RE: DA-2020/1585- 60 CASTLE CIRCUIT, SEAFORTH

Reference is made to Council's letter dated 25 February 2021 from Anna Williams, Manager, Development Assessment, Northern Beaches Council. Thank you for providing additional time to address the issues raised in your letter. After discussions with the client and architect, amendments have been carried out to address the issues, where feasible or reasonable (in our opinion).

Figure 1: Excerpt of Section A noting the relationship between the proposed excavation works and the boundaries

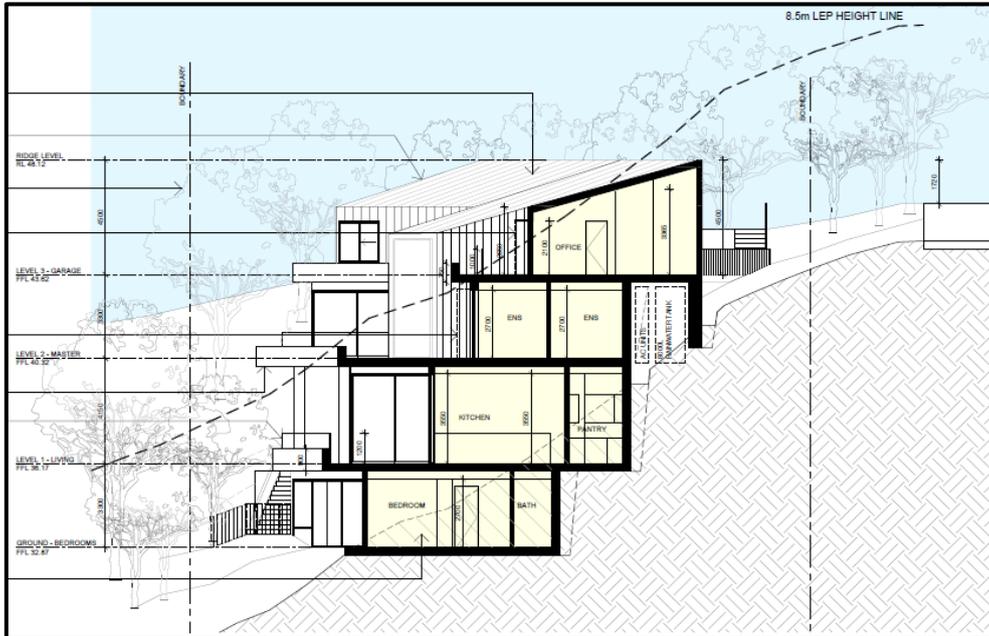
The excerpt of the sections below shows that no change to the natural ground level is proposed along the west, south and north boundaries. Additional cross-sections of the west boundary have been provided as requested in Council's letter, which exhibit the proposed terraced landscape around the pool. Refer to DWG 2019-011-303.

Figure 4: Excerpt of the landscape plan

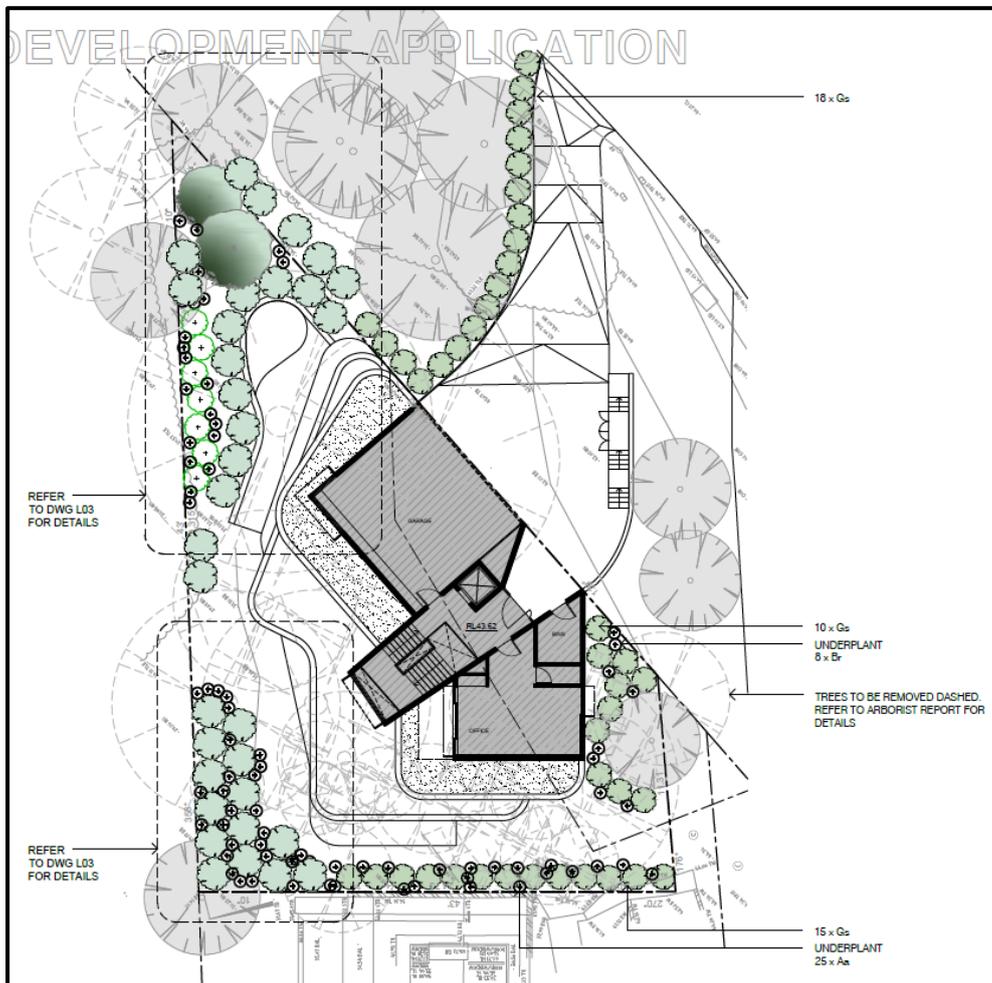
The proposed high-quality landscape design has been thought to complement the Landscape Heritage Item and Terrestrial Biodiversity surrounding the area whilst being compatible with the planting recommendations to developments in Bush Fire prone zones. The amended landscape plans have increased planting within the whole site, allowing for greater vegetation coverage, particularly along the boundaries, which ensure a better privacy relationship between the proposed dwelling and neighbouring properties.

Figure 6: Excerpt of Section D noting the reduced built form and the relationship between the proposed amendment with the adjoining southern neighbour

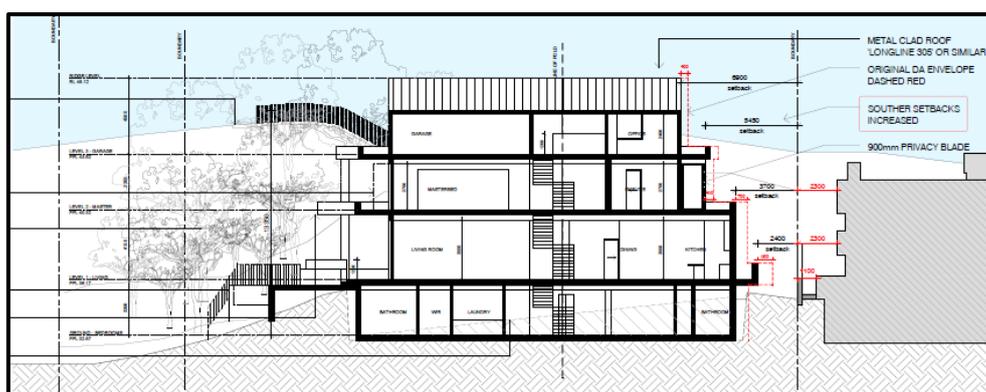
The amended plans include a reduction of the FSR to achieve full compliance under concession contained in the DCP – part 4.1.3.1, which allows for an increased FSR for undersized lots. The proposed FSR is 0.4:1, which was achieved by increasing the southern setback to the shared boundary with the neighbour at No. 58 Castle Circuit, as shown in **Figure 6** below and amended plans submitted.

The design amendment will improve the relationship with the surrounding properties, particularly with the adjoining southern residence. The proposal improves the amenity to the property at No.58 in regard to solar access by providing for increased setbacks from the southern boundary, allowing for better sunlight access to the northern elevation, living areas and POS. Shadow Diagrams accompany this submission and demonstrate that a minimum of 3 hours of direct sunlight between 9am and 3pm in mid-winter will be maintained.

Figure 8: Excerpt of the Site Plan noting the deletion of the southern stair access associated with the adjacent access driveway area to the east of the subject site and retention of pedestrian access to the north

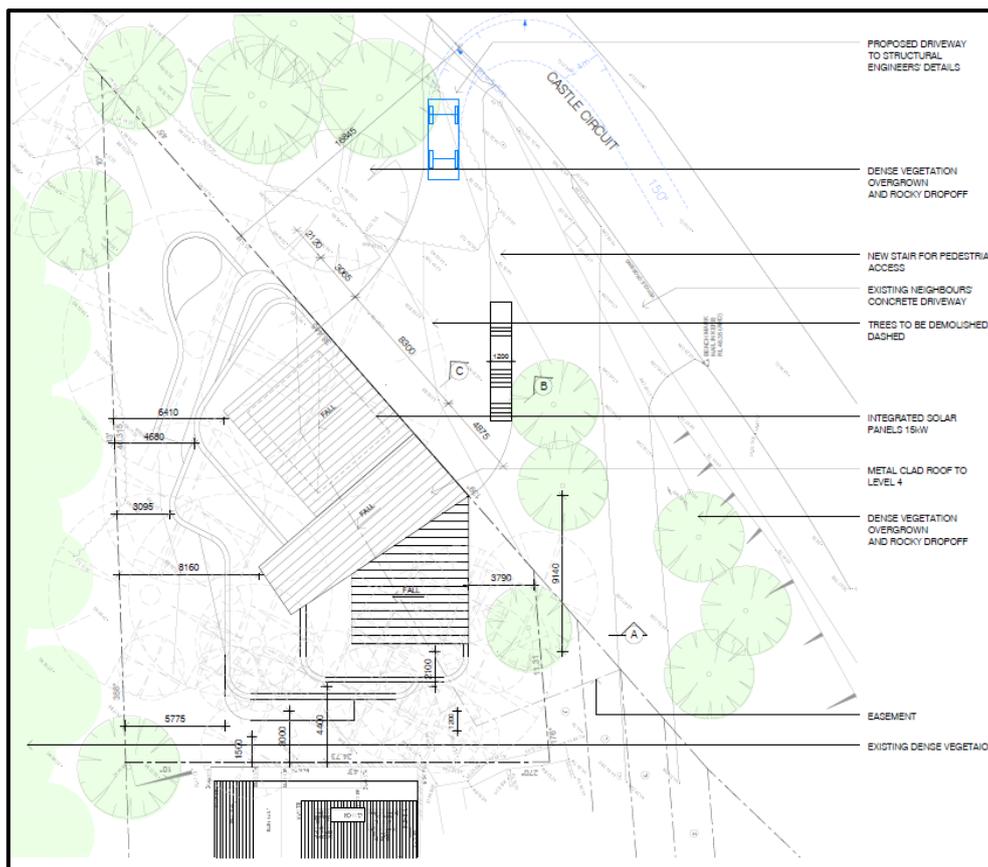
In response to the concern raised by proprietors of property No.52 and Council, the access stair adjacent to the southern boundary has been removed from the proposal. As shown on the amended plans below, the stair up and access, which had an encroachment with the adjacent access driveway shared by properties at No. 52, 54, 56 and 58, has been deleted. The proposed steps down retained follow the natural ground level and are fully sited within the site. It will not result in access or any circulation to the carriageway parallel to the eastern boundary. The amendment is considered to suitably address such concerns.

It is reiterated that the only pedestrian access provided to the site is located to the north boundary in association with the proposed driveway to the development and does not generate any adverse impact on southern residences regarding safety and security or privacy. The pedestrian access stairs to the north of the site do not encroach with the shared driveway built on privately owned land. It is situated approximately 5.2m from the driveway combined with proposed retained trees that screen and distinctly separate public and private domains.
